**Proposed Vehicle X-Over Fronting onto a Classified Road. 5 Forge Lane,
Higham. ME3 7AS. Pursuant to Refusal Ref 20250570.**

Further to our letter dated the 26th of June 2025, we have reviewed KCC's review (letter dated 3rd July 2025) and response recommending refusal. This is concerning as the previous application received no objections from KCC. We suggested previously that the KCC case officer may have changed hence we are now submitting our final amendments. Our letter of the 26th June may not have been reviewed by KCC based on the comments to date. We did highlight previously some of our documents were missing on the portal.

Depth and Width to Parking Area

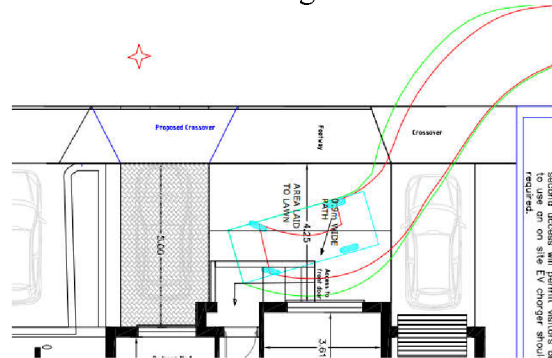
In re-visiting this application it is noted that whilst the length of the driveway is shown to be 5m in length, the presence of the wall in the north-eastern corner (adjacent to the front door), reduces the length to 4.25m x 2.4m (or 5m x 2m). This does not meet the required 4.8m x 2.4m dimensions set out in the KCC vehicle crossover guidance, nor the required 5m x 2.5m set out in SPG4 (the current adopted parking standards in Gravesham). As set out in the previous response, the KCC vehicle crossover team is also unlikely to accept the proposal as it would not meet the minimum 4.5m of full height kerb between the crossovers.

The parking space is wider, please refer to drawing TAB/06/209B, hence less planting on the southern side of the parking area. The area/width between the house where the car will park is 2.75m in width. The depth is 5m. These dimensions accord with KCC's response.
